**COLORADO DEPARTMENT OF TRANSPORTATION
REGION 1
2000 South Holly Street & 5640 East Atlantic Place
Denver, CO 80222**

Summary Observations

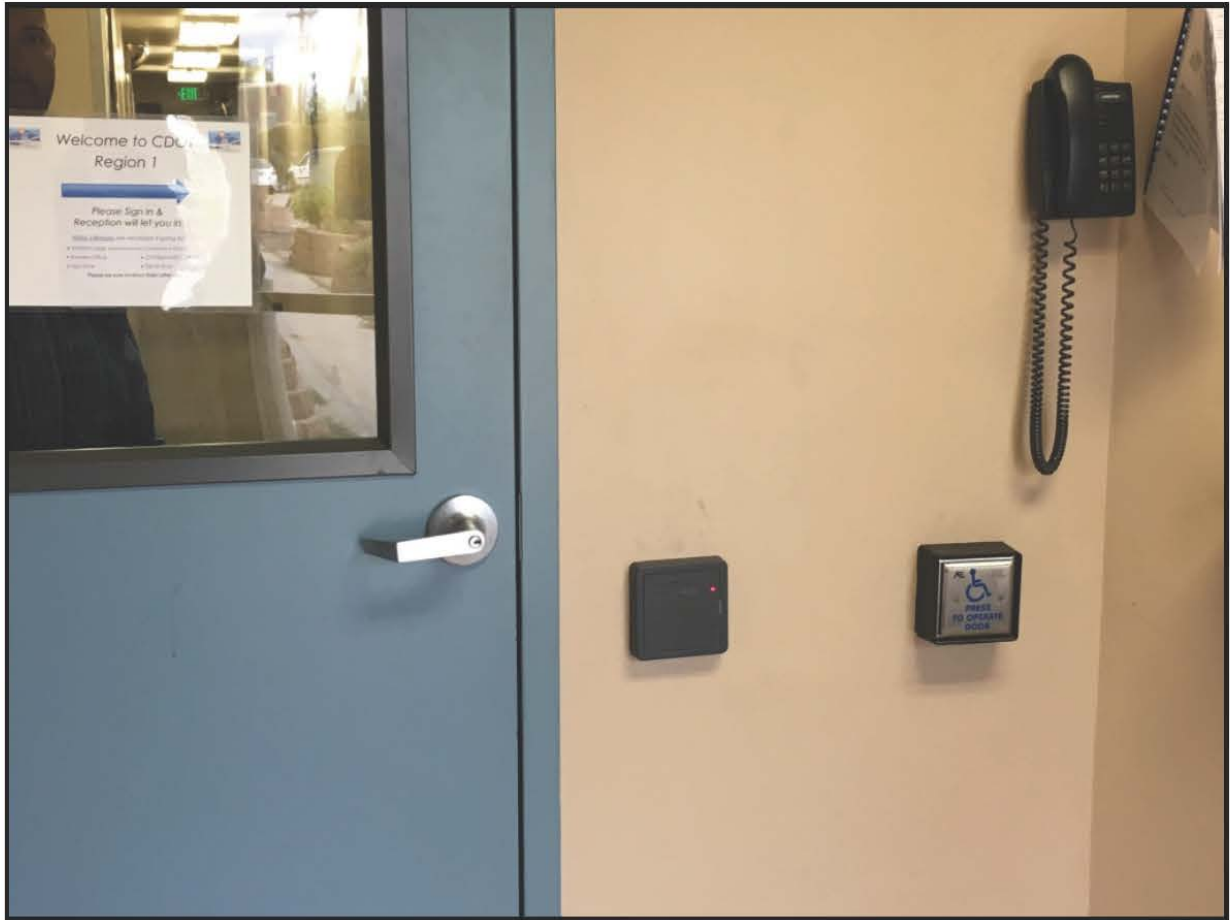
Conference room signs should include Braille & raised letters

Sign should be on latch side of door

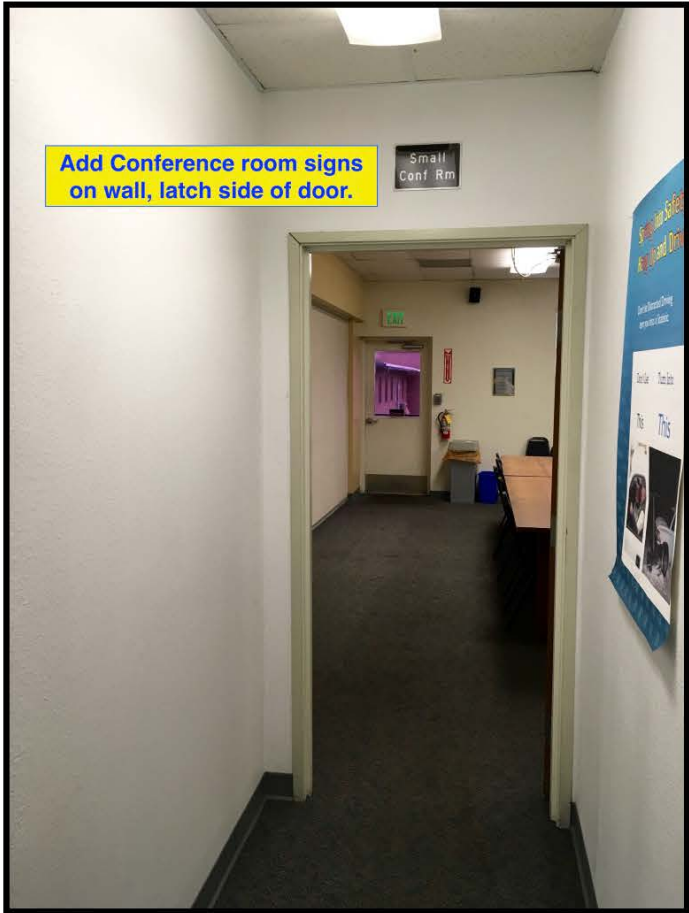
Raise signs to 60"

**Flush Handle should
be on open side**
